UNITED STATES  
DEPARTMENT OF THE INTERIOR  
BUREAU OF LAND MANAGEMENTFORM APPROVED  
OMB NO 1004-0135  
Expires July 31, 2010**SUNDRY NOTICES AND REPORTS ON WELLS**  
*Do not use this form for proposals to drill or to re-enter an abandoned well. Use form 3160-3 (APD) for such proposals.***SUBMIT IN TRIPLICATE - Other instructions on reverse side.**

## BP - San Juan Plugging Procedure

GCU 190E  
30-045-25450

Re: Permanent Abandonment  
Well: 190E Gallegos Canyon Unit

## Current Wellbore Diagram

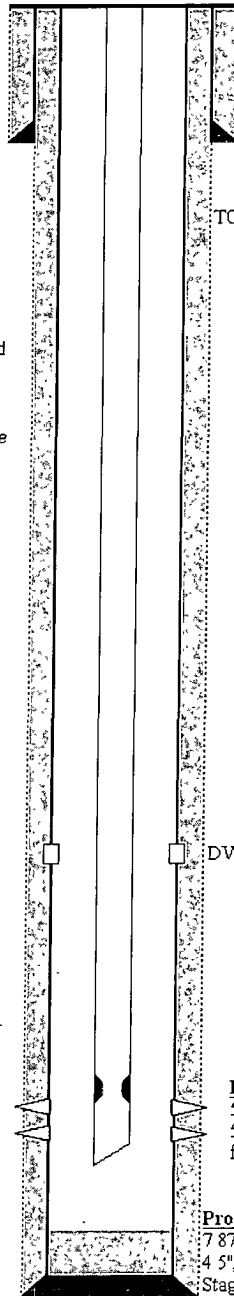
3. The following modifications to your plugging program are to be made:

a) Place the Mesaverde/Pictured Cliffs plug from 2152' – 1168'.

b) Place the Fruitland plug from 948' – 848'.

c) Place the Kirtland/Ojo Alamo/Surface plug from 388' to surface.

\* Place Surface plug from 511' - 0'

\* Move top of Fruitland plug to 818' (948'-818')

\* Add plug @ 2480' - 2380' to cover MV pool top

\* Add plug @ 4090' - 3990' to cover Mancos top
